## Product Change Notice (PCN)

**Subject:** Change Leadframe Supplier

**Publication Date:** 12/23/2022

POD Current Leadframe Supplier  
(CWTC, Japan)

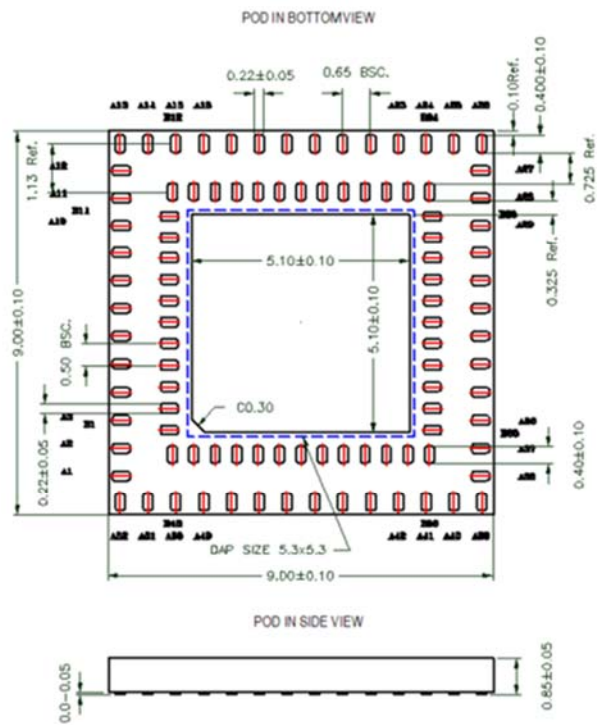
This notification is to advise our customers that Renesas is changing leadframe supplier from CWTC, Japan to Rokko, Malaysia due to the current supplier has ceased the operation. There will be no change to the leadframe base material, Eftec-64T as well as the package outline drawing since the new supplier follows exactly the existing supplier's leadframe drawing.
